**DEPARTMENT OF TRANSPORTATION**

Contract #: 04-0120F4Cty: SF/ALA Rte: 80 PM: 13.2/13.9File #: 69.28**WELDING INSPECTION REPORT****Resident Engineer:** Pursell, Gary**Address:** 333 Burma Road**City:** Oakland, CA 94607**Report No:** WIR-007346**Date Inspected:** 11-Jun-2009**Project Name:** SAS Superstructure**OSM Arrival Time:** 700**Prime Contractor:** American Bridge/Fluor Enterprises, a JV**OSM Departure Time:** 1900**Contractor:** Zhenhua Port Machinery Company, Ltd (ZPMC), Changxing Island **Location:** Shanghai, China**CWI Name:** Wu Zhi Cheng**CWI Present:** Yes No**Inspected CWI report:** Yes No N/A**Rod Oven in Use:** Yes No N/A**Electrode to specification:** Yes No N/A**Weld Procedures Followed:** Yes No N/A**Qualified Welders:** Yes No N/A**Verified Joint Fit-up:** Yes No N/A**Approved Drawings:** Yes No N/A**Approved WPS:** Yes No N/A**Delayed / Cancelled:** Yes No N/A**Bridge No:** 34-0006**Component:** OBG Segments**Summary of Items Observed:**

Segment 5BE

Segment 1BE

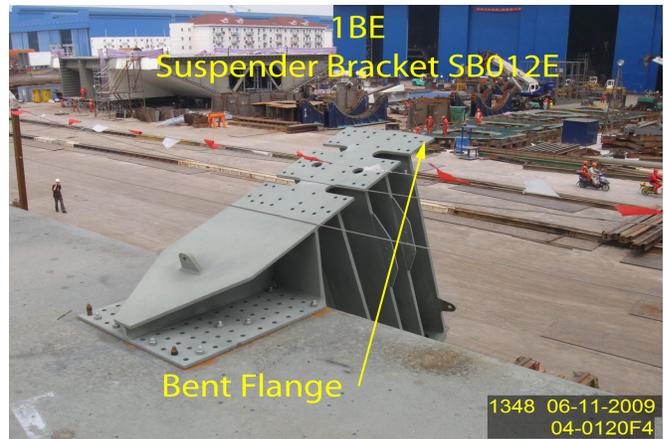
This QA Inspector observed the top flange on Suspender Bracket SB012E on Segment 1BE is bent.
